A d d e n d u m

Iowa Department of Transportation
Office of Contracts

B.O.	Proposal ID	Proposal Work Type	County	Project Number	Addendum
306	78-0293-102	GRADING	POTTAWATTAMIE	IM-NHS-029-3(102)48--03-78 IM-NHS-029-3(103)48--03-78 IM-NHS-029-3(104)48--03-78 IM-029-3(105)48--13-78 NHS-029-3(106)48--11-78 IM-NHS-029-3(110)48--03-78 IM-NHS-029-3(122)48--03-78 IM-NHS-029-3(146)48--03-78 IM-NHS-080-1(416)3--03-78	17FEB306.A03

Project NHS-29-3(106)--11-78

Replace Sheet 54 with attached Sheet 54.

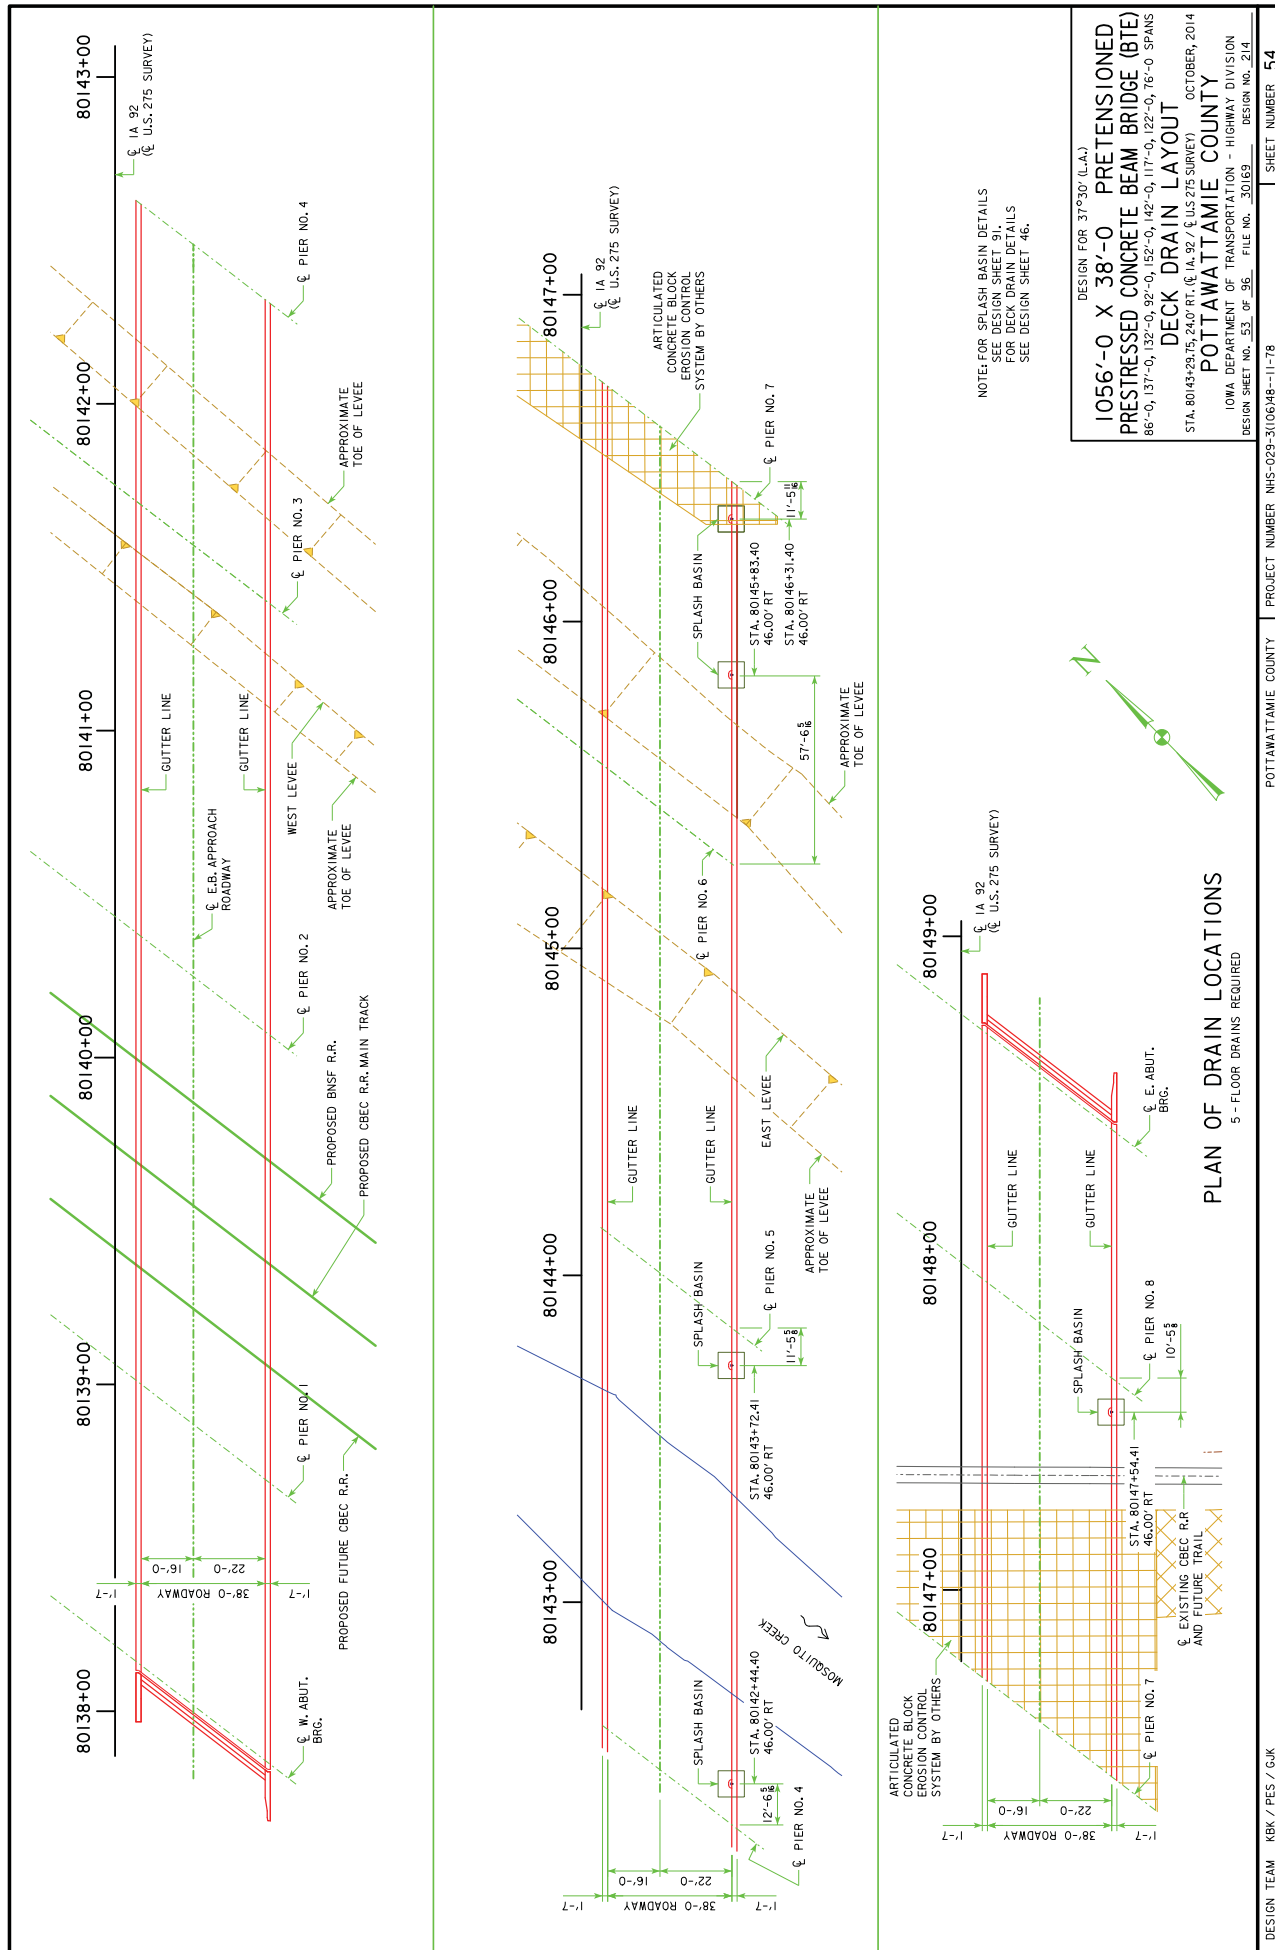
Added Articulated Concrete Block Erosion Control System adjacent to Pier 7.

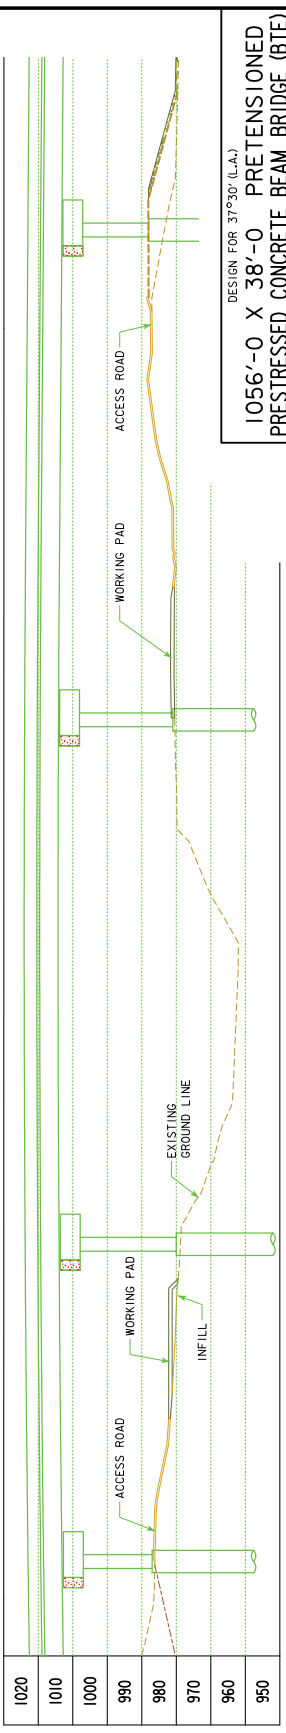
Revised Working Pads to accommodate the piggyback extension. Revised Working Pad Notes.
